# **Independent review of Menston flooding problems**

Dr Duncan W Reed

11 December 2014

## Executive summary

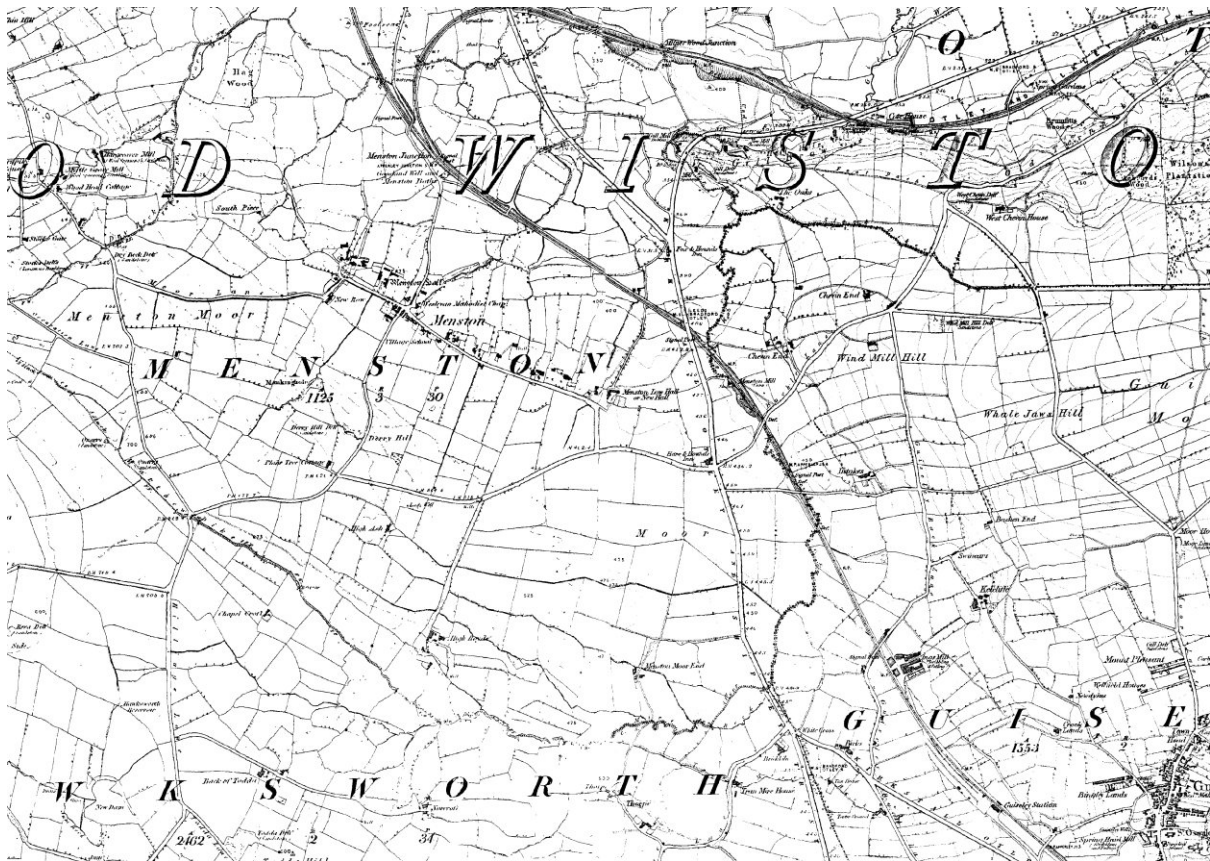
The description (see Box 8.1) of ME/002 as a level area of land is incomprehensible. Immediately east of Derry Hill, the land is steeply sloping (see Figure 8.1a).

The current designation of ME/008 (land north of Bleach Mill Lane) as unsuitable is understandable, not least given the difficult access via Bleach Mill Lane. However, undesignated land south of Bleach Mill Lane is less steeply graded (see Figure 8.1b) and might be accessible via Moor Lane.
